UNITED STATES PATENT AND TRADEMARK OFFICE

APPLICATION NO.	FILING DATE	FIRST NAMED INVENTOR	ATTORNEY DOCKET NO.	CONFIRMATION NO.
09/752,651	12/29/2000	Robert C. Glenn	42390P9716	1502

NON-FINAL OFFICE ACTION

Fig. 6

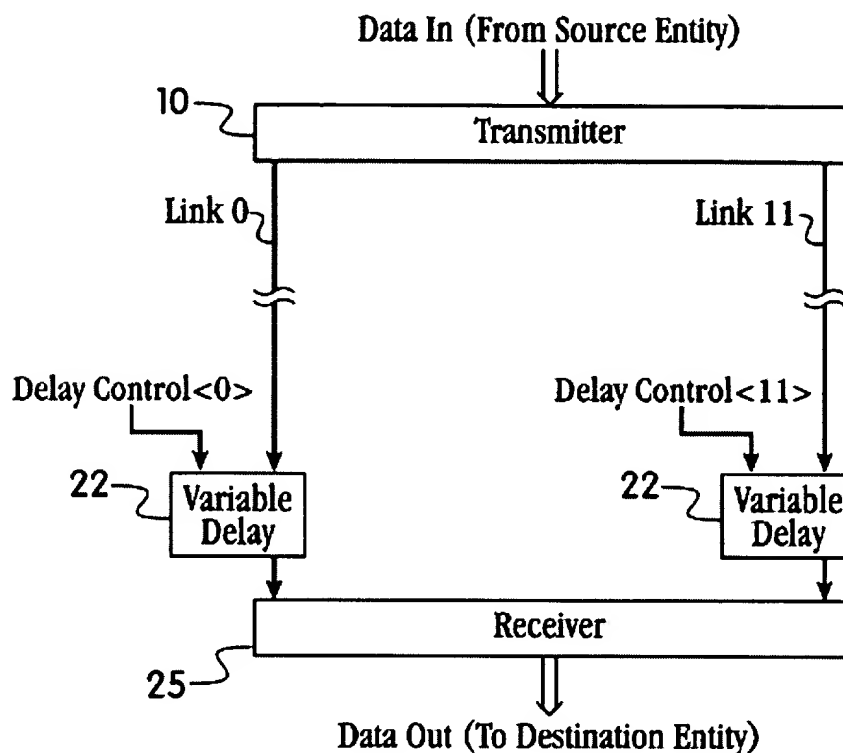
As per Claims 1, 3-29, Widmer depicts, e.g., in Fig. 6 and related description in col. 1 line 13 et seq., the claimed method, comprising: a) measuring a skew between a data signal and a clock signal at a receiving end of a serial link; and b) adjusting (col. 2 line 27) a phase relationship between said data signal (col. 2 line 30) and said clock signal (col. 2 line 29) to reduce said skew via variable delay means implementable in hardware or software, e.g., in CPU or other digital component: Refer, e.g., to Fig. 6: block 22 and col. 2 line 23 et seq.

Widmer further teaches means to impose delay on one or both signals as seen in Fig. 6. And wherein said adjusting a phase relationship further comprises adjusting a phase offset between a pair of phasors associated with a pair of phase interpolators, a first of said phasors used to derive a second clock signal that times the transmission of said data signal, a second of said phasors used to derive said clock signal in col. 2 line 27 wherein equivalent means are provided for eliminating skews via multiple values of a period to effectively result in phase

interpolation means. Also refer to Fig. 6 wherein variable delay blocks 22 are configured to delay signals on the links by more than 360 degrees.

FIG. 12

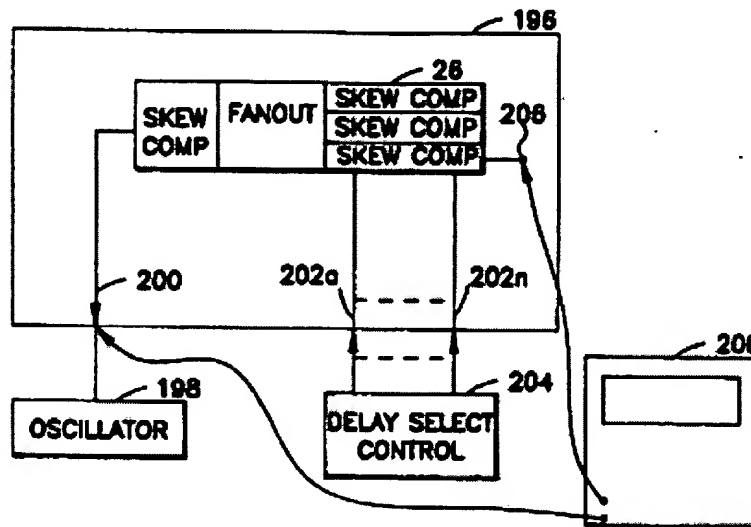
As per Claims 1, 3-29, Nelson et al. anticipates the claimed technique for adjusting clock skew comprising: means for measuring skew between a test/clock signal and a data signal at a destination of a link (Fig. 4 *numeral 44*), means for determining amount of skew compensation required, and means for injecting (Fig. 4 *block 26*) such amount of skew compensation into the sending side (Fig. 4 *numeral 34*) of such link, e.g., in Figs. 4 & 12 and related description at col. 1 line 8 et seq.

Accordingly, Nelson et al., in an analogous art, discloses skew compensation wherein skew is detected at the receiving end of end of the serial link, such skew being compensated at the transmit end wherein such skew compensation is caused by adjusting phase of a signal. {See **Nelson et al.**, Id., e.g., Figs. 4 & 12 and col. 5 line 23 et seq.}
